PERCOLATION TESTING

PRELIMINARY PLAN TIMBERLEIGH HOMESTEADS

From: Oswald, Hank <hoswald@howardcountymd.gov>
Sent: Monday, April 11, 2022 7:56 AM
To: Ron Thompson <ron@vanmar.com>
Subject: OSDS Plan_3408 Woodbine Road

The revised OSDS Plan has been reviewed with the following comments:

A 42381

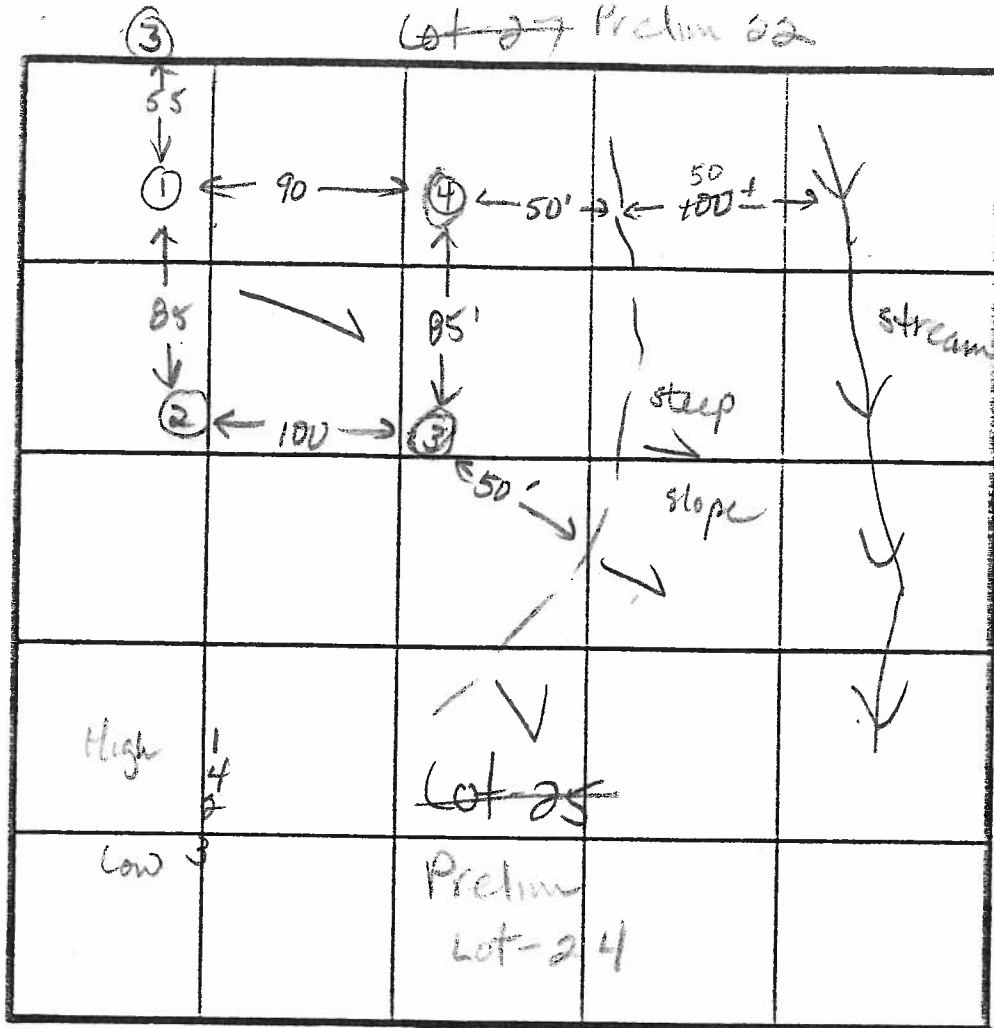
REASONS FOR REJECTION OR HOLDING 11-23-88 Recommend rejection due to shallow refusal depth. JEA

REMARKS Holes # 2, 3, & 4 are less than 200 ft minimum to stream. All holes as shown on plat. Holes # 1 & 2 not tested.

A 42379

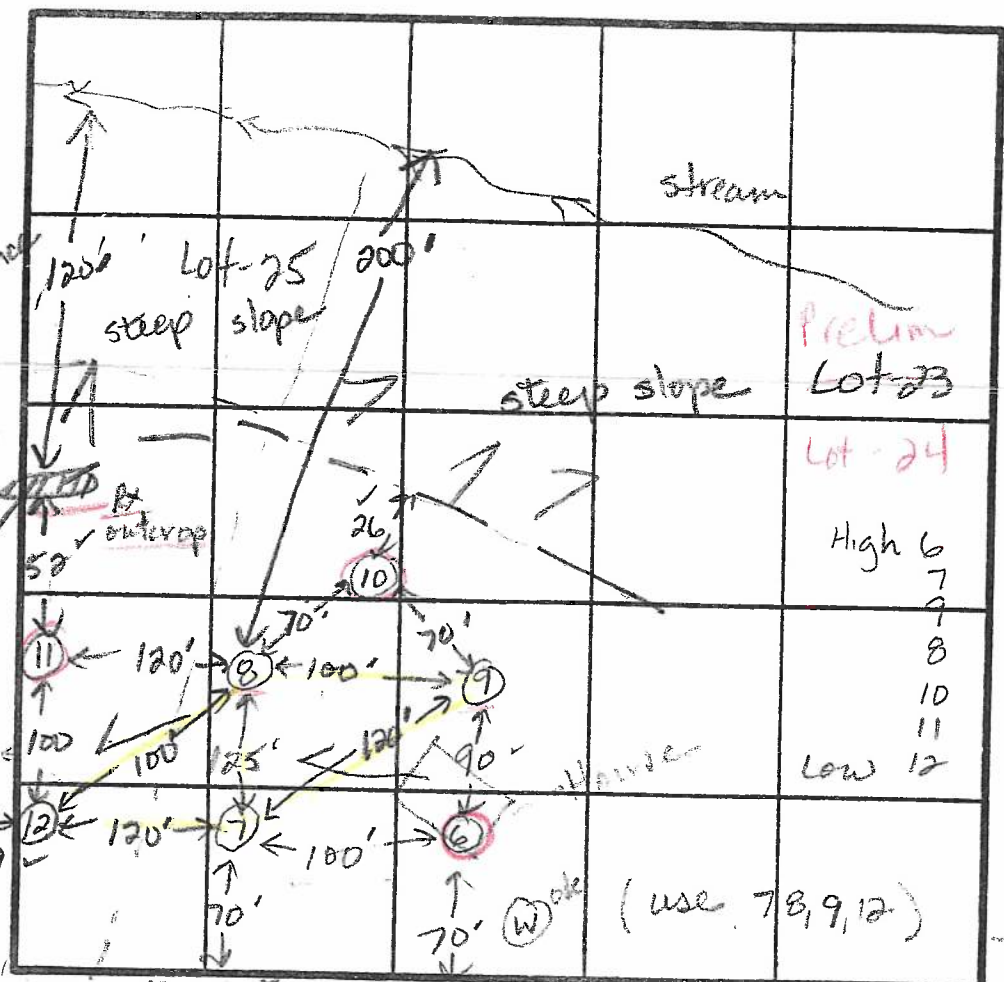
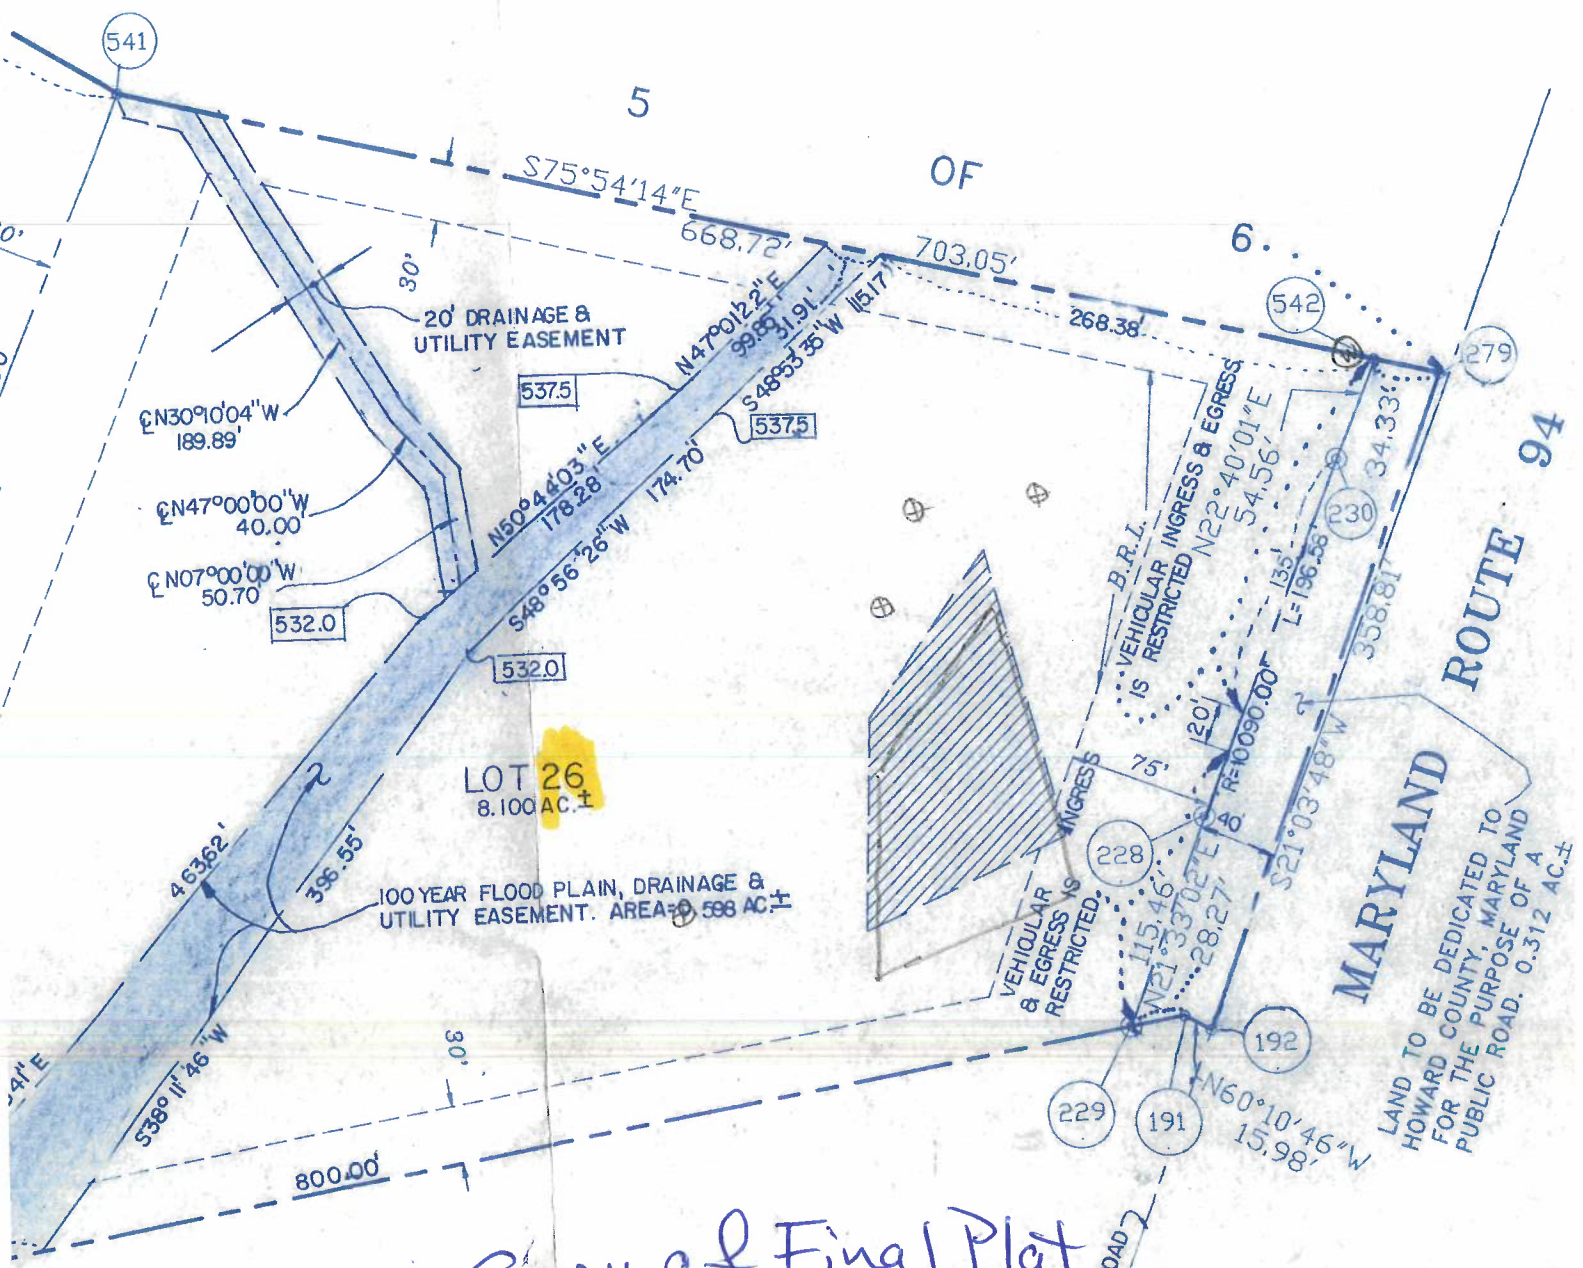
REASONS FOR REJECTION OR HOLDING 12-1-88 Unclear as to 10,000 sq ft area available. Very limited house & well site. Hold for perc hole locations and subdivision plat approval. SHALLOW ONLY DEN.

REMARKS All holes moved. Some on Lot-25. Very limited because
and well site.

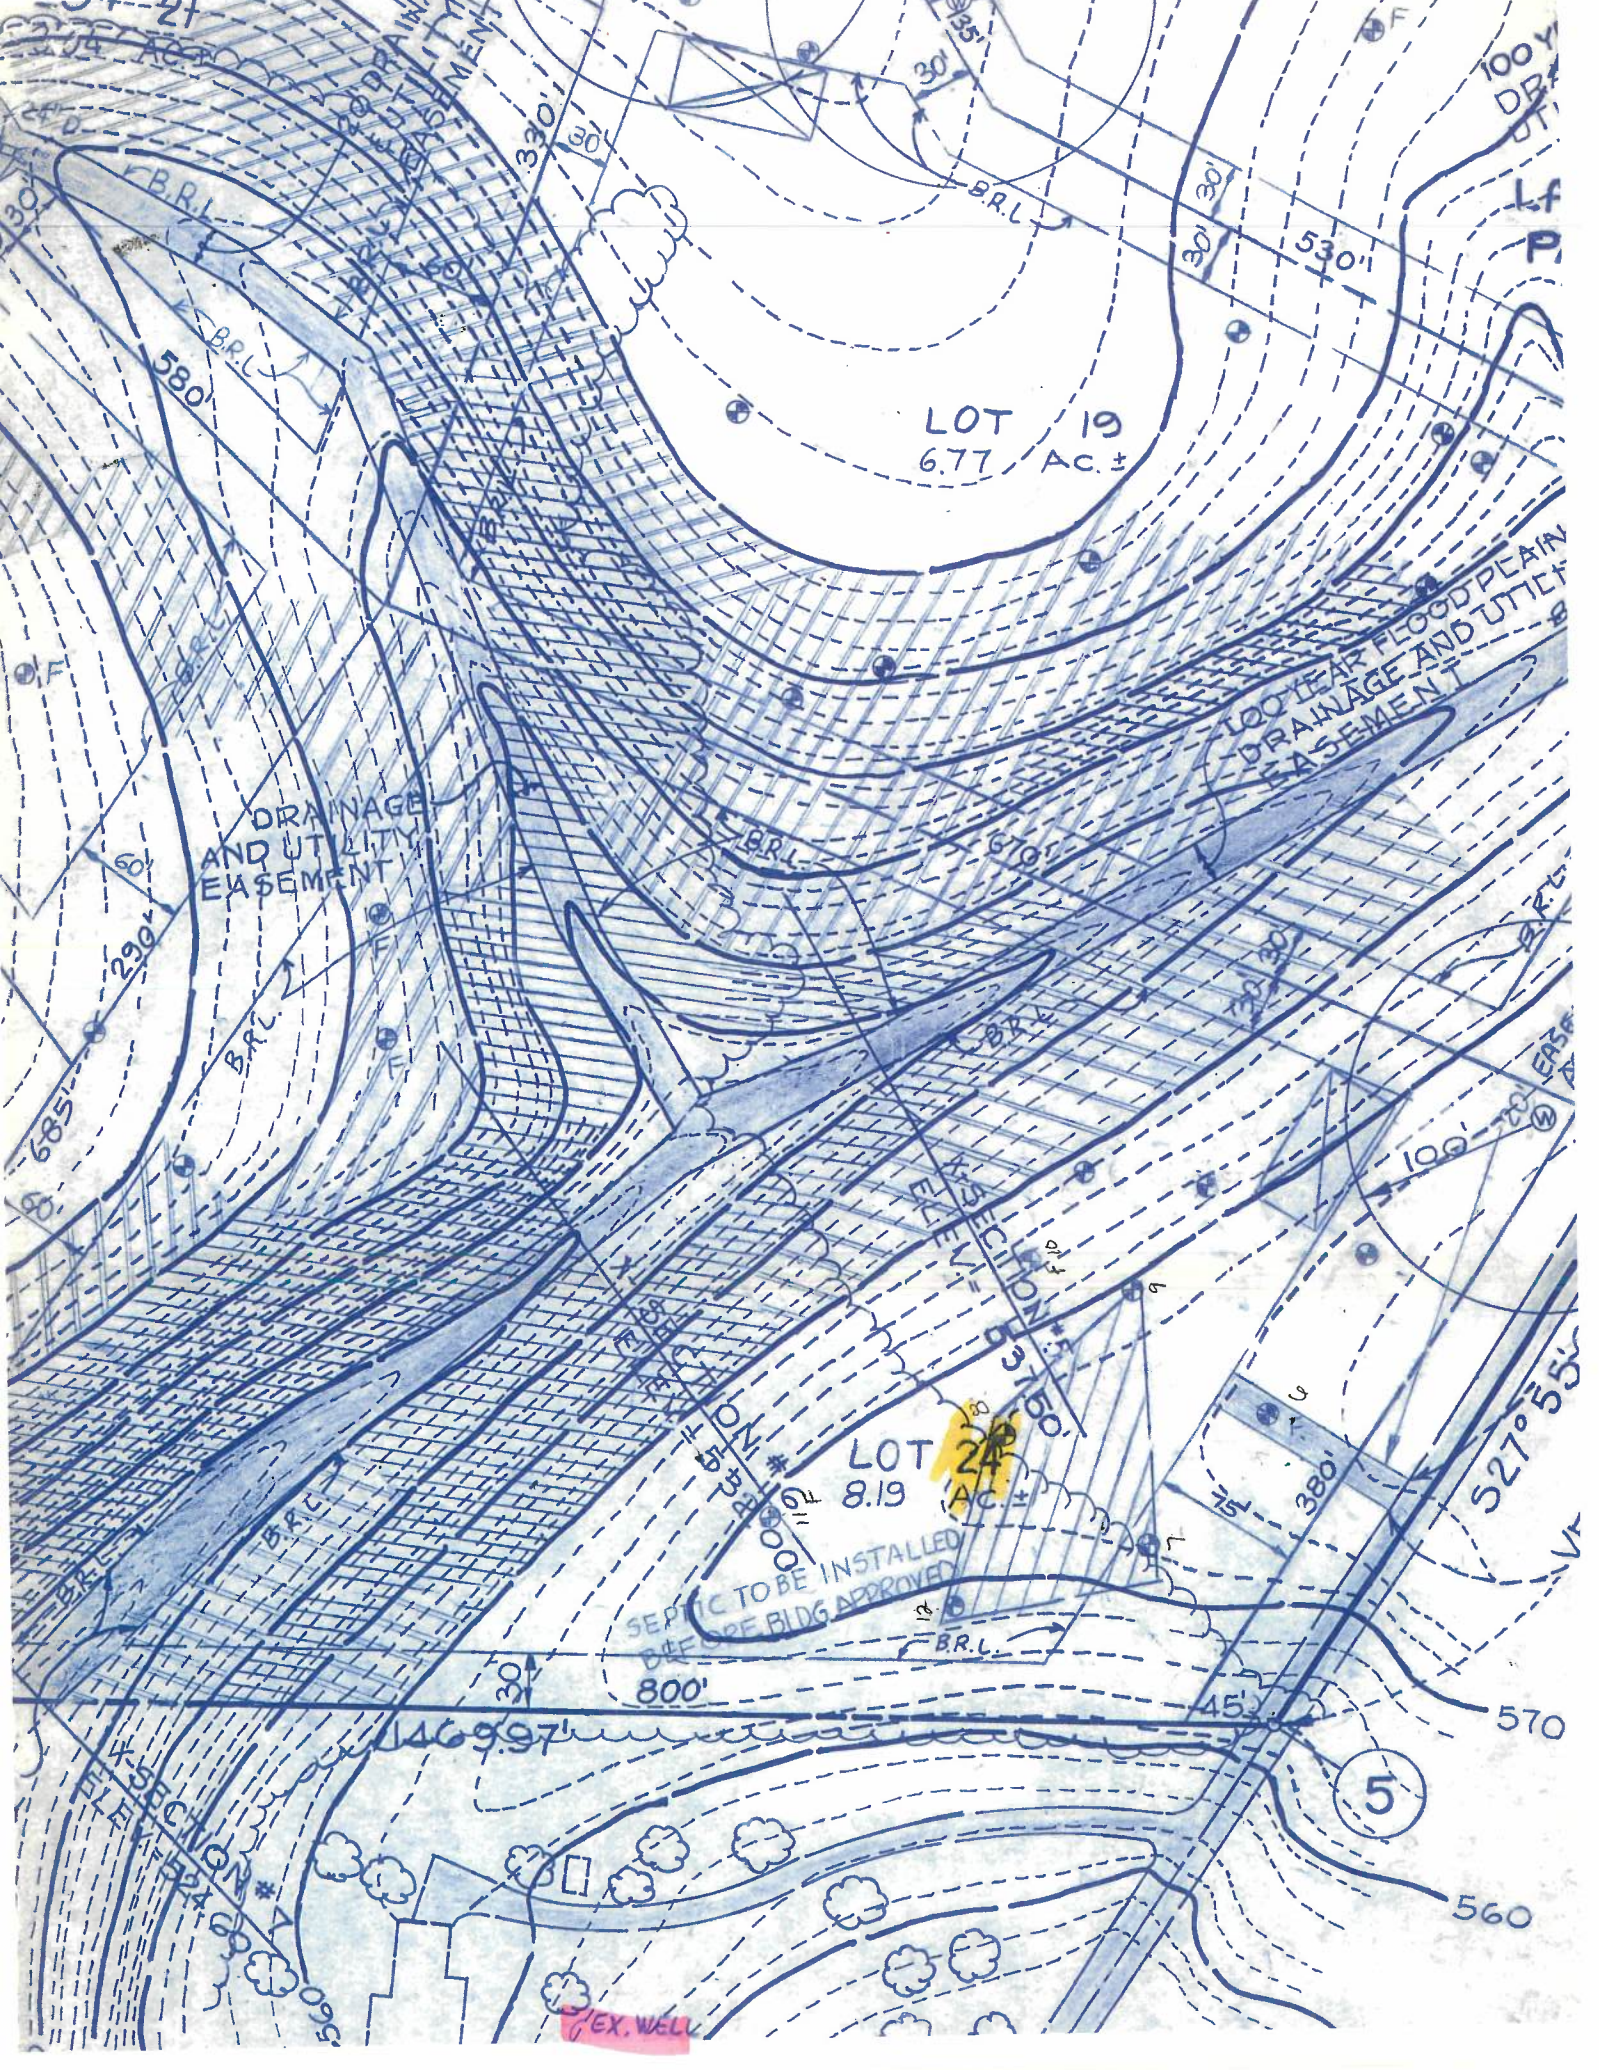
1. Match passing perc test symbol on plan with legend symbol
2. Add legend symbol for failed perc test holes
3. Shape of SDA does not match approved area on perc cert plan
4. Utilize top area of SDA (1st replacement not on contour. 2nd replacement should be fine.)
5. Per as-built drawing, existing trench T1-3 is located slightly outside the SDA

1. Match passing perc test symbol on plan with legend symbol **Symbols updated**
2. Add legend symbol for failed perc test holes **Symbol added to legend.**
3. Shape of SDA does not match approved area on perc cert plan **Outline of SDA corrected.**
4. Utilize top area of SDA (1st replacement not on contour. 2nd replacement should be fine.) **contours updated from field survey.**
5. Per as-built drawing, existing trench T1-3 is located slightly outside the SDA **Trench T1-3 located corrected.**

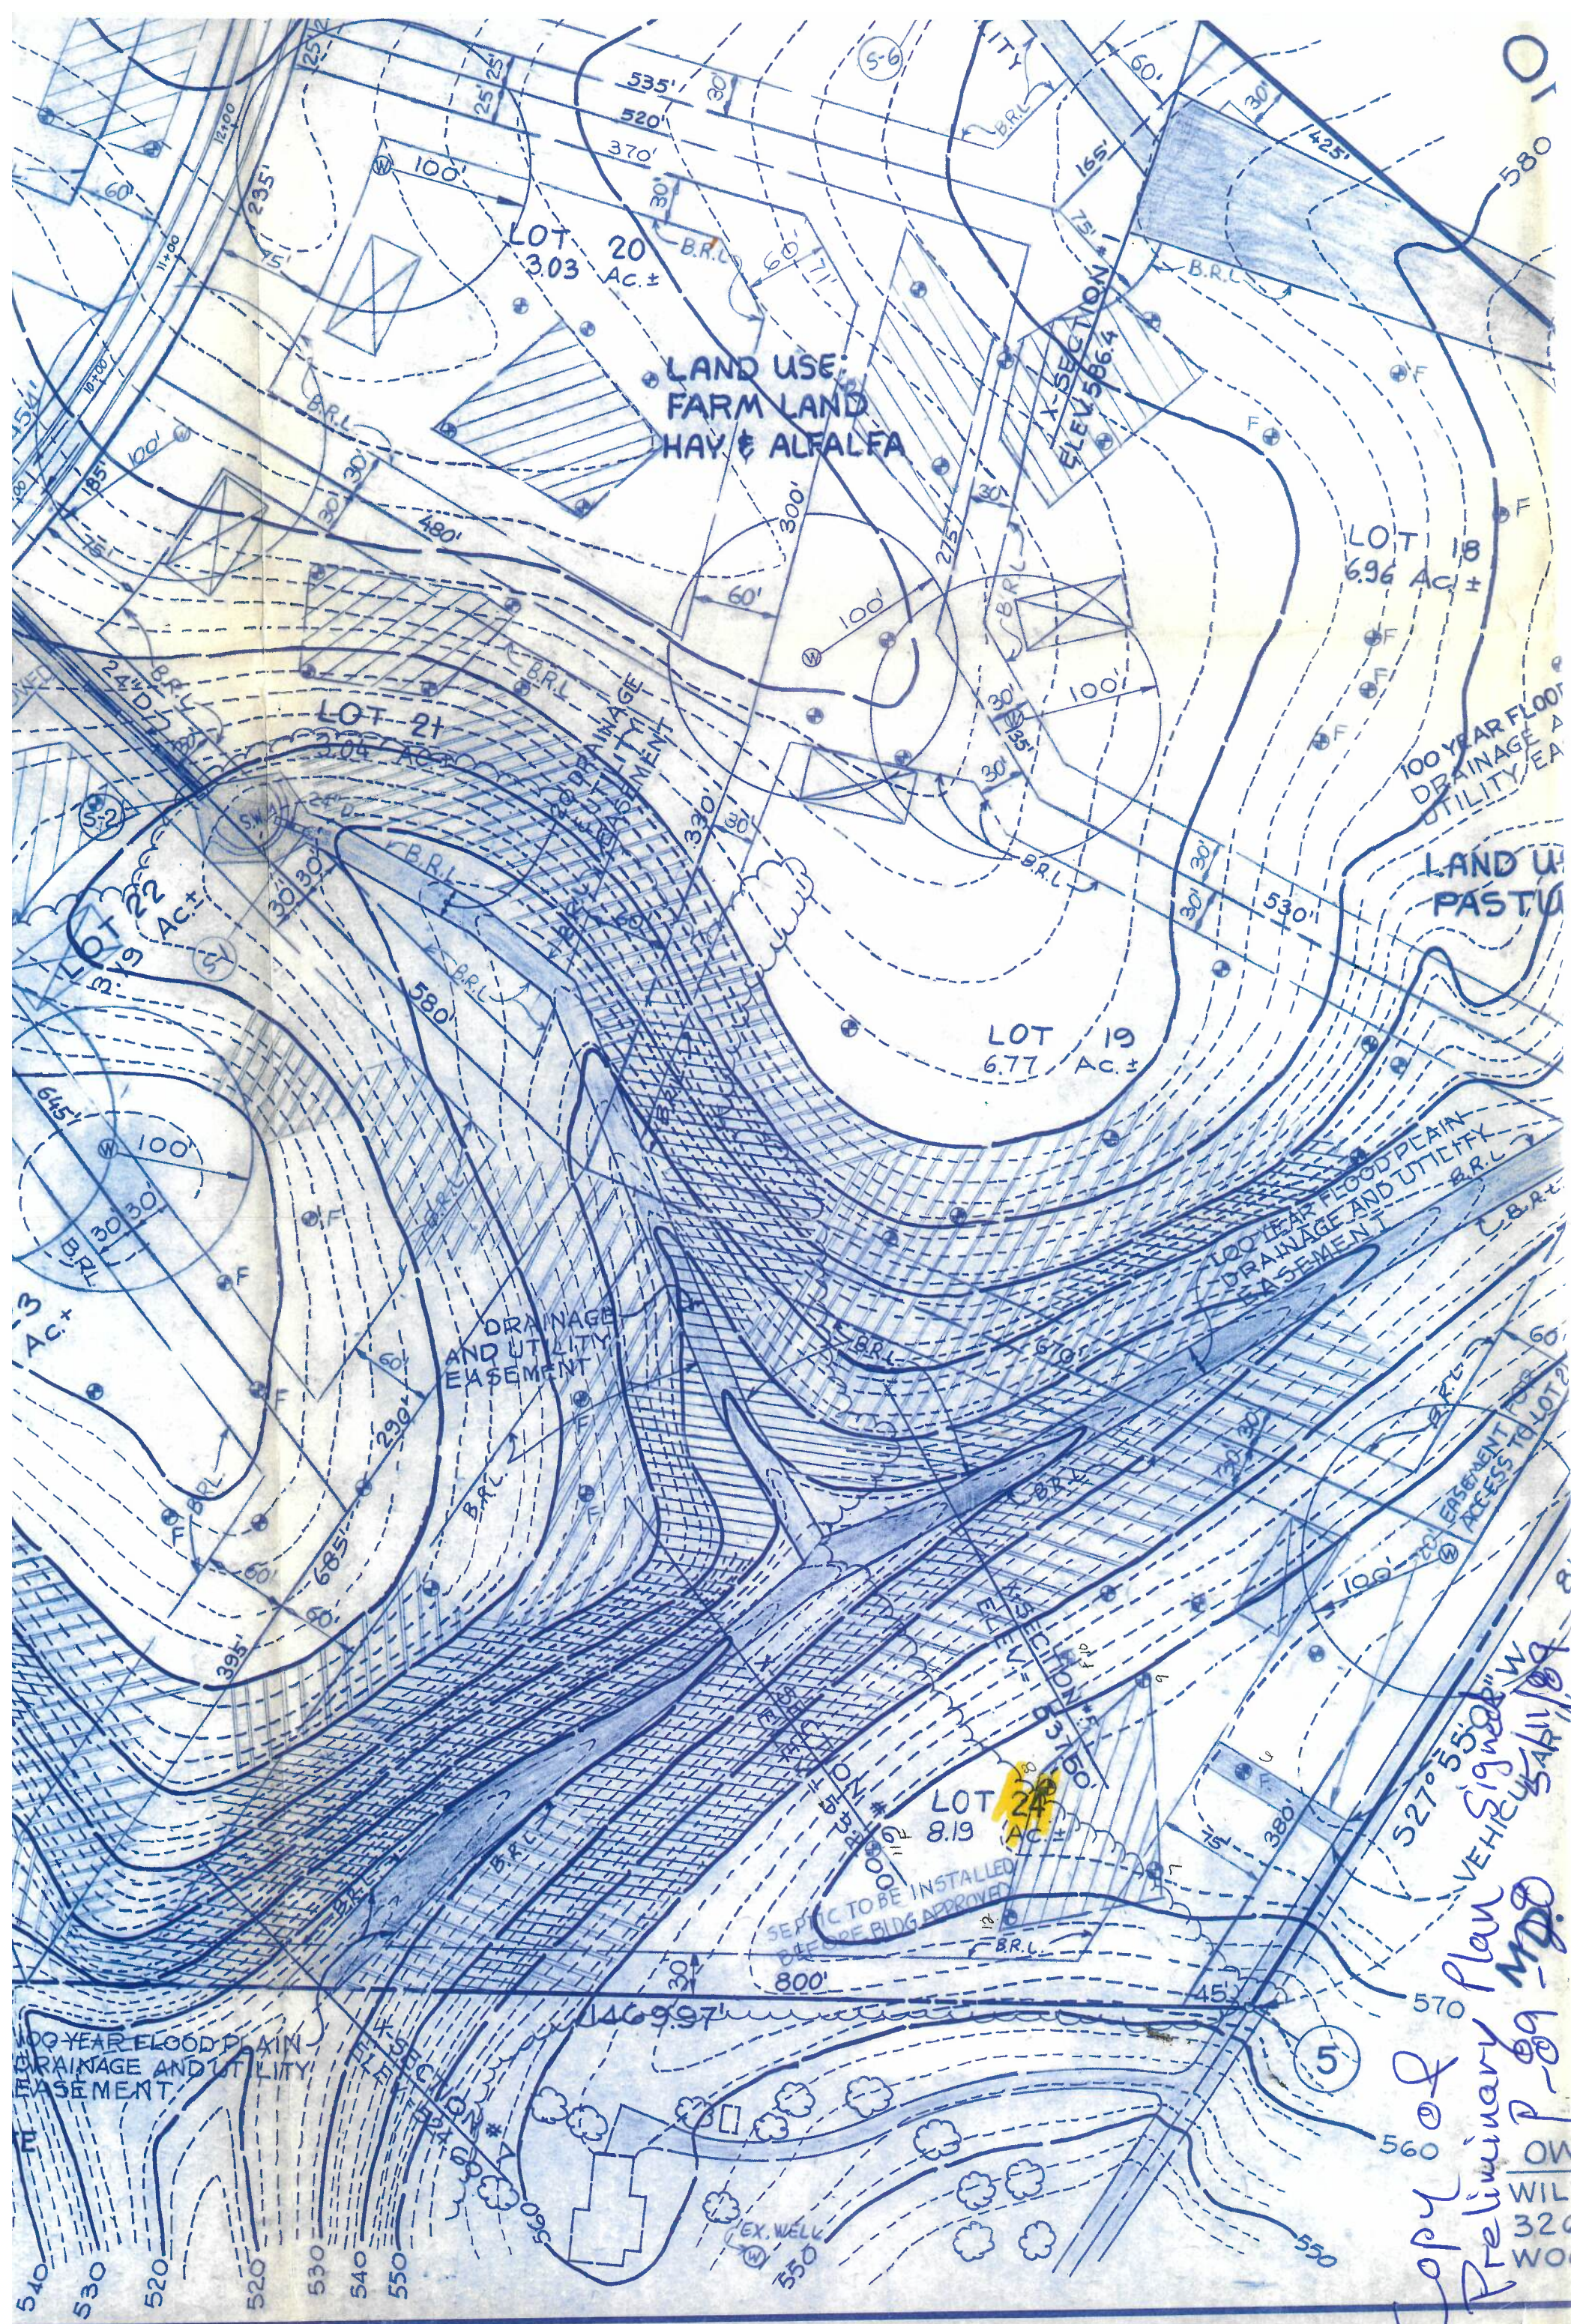
Good morning. The inspector and septic contractor successfully installed 3-70' trenches as shown on the as-built drawing (see attached), however perc test hole "P1" showed greater than 50% rock at 7 feet. With the results of P1, we would like to see how the newly installed system plus 2 replacement systems fit around test hole P1 using a 15 ft. radius.
